Wind Noise from Front Side Glass

YEAR(S)	MODEL(S)	ADDITIONAL INFORMATION
2010	RX350

TSIB REVISION NOTICE

February 9, 2010 Rev1:

Figure 1.

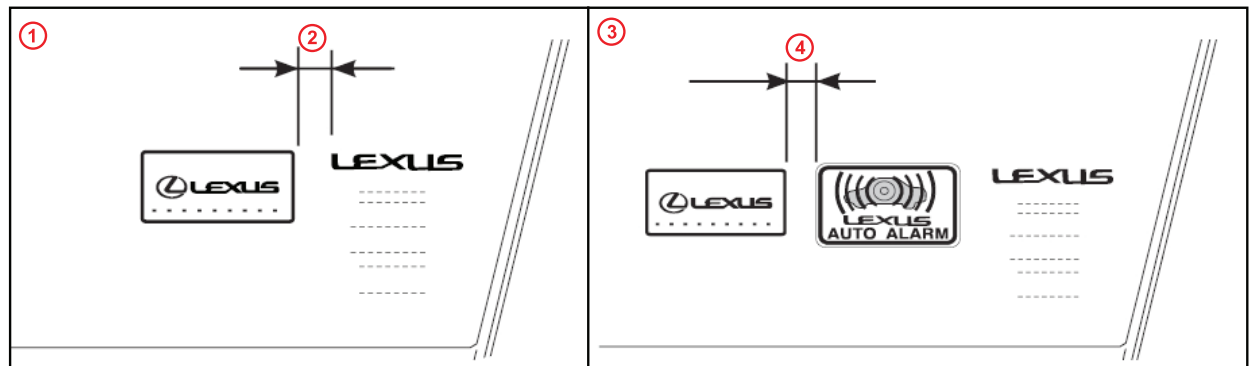
4. Install window labels in correct position.
 - A. Use household glass cleaner to clean the inside of the front door windows.
 - B. Use a piece of clear tape to lift the label from the protective backing.
 - C. Attach the label as shown in Figure 1.
 - D. Repeat steps A–C with the other window

NOTE
Compare original glass to new glass to make sure labels match.

Figure 2.

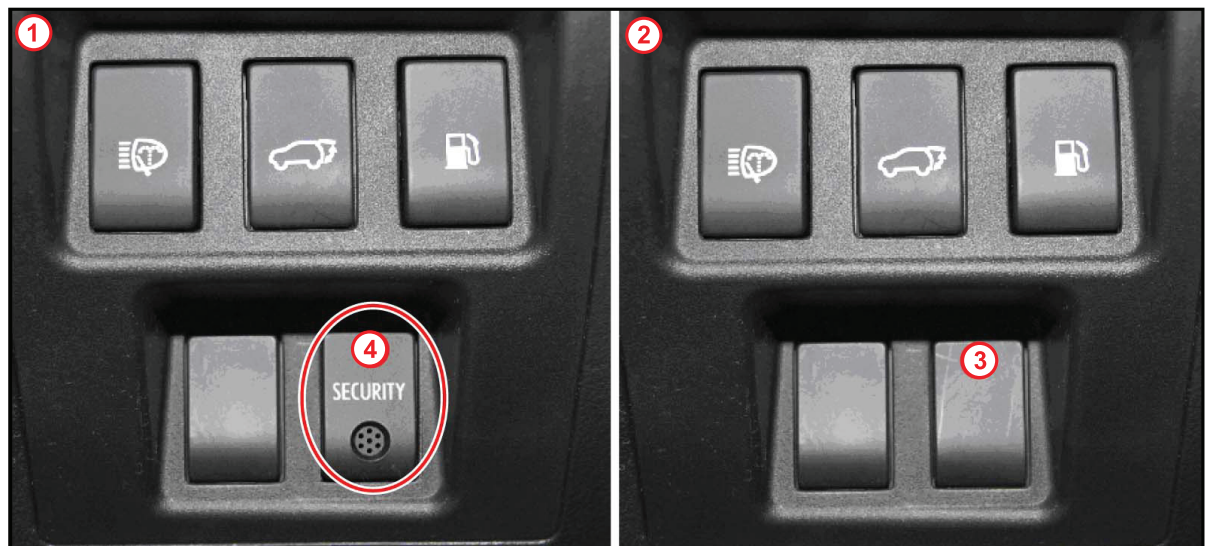
- A. For vehicles equipped with a Glass Breakage Sensor, the sensor position and/or system sensitivity will need to be calibrated for the new glass.
- B. Determine if the Glass Breakage Sensor was installed at the Factory or as a Post Production Option (PPO)/ Dealer Installed Option (DIO).

- C. If Factory Installed, follow the PPO/DIO Glass Breakage Sensor Accessory Installation Procedure in TIS to adjust GBS system sensitivity for acoustic glass.

Figure 3.

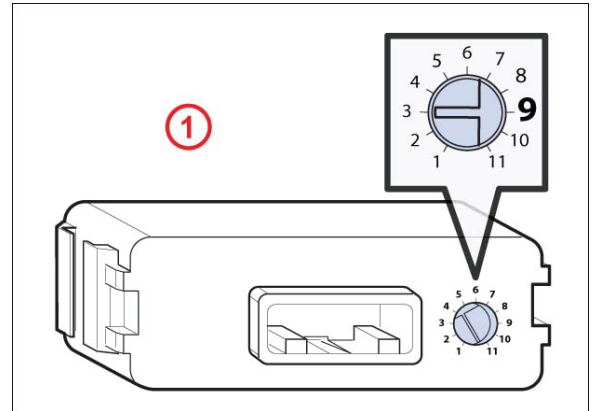
- D. If PPO/DIO, follow the PPO/DIO Glass Breakage Sensor Accessory Installation Procedure in TIS to adjust GBS system sensitivity and relocate the GBS microphone for acoustic glass.

System Sensitivity should be set to 9.
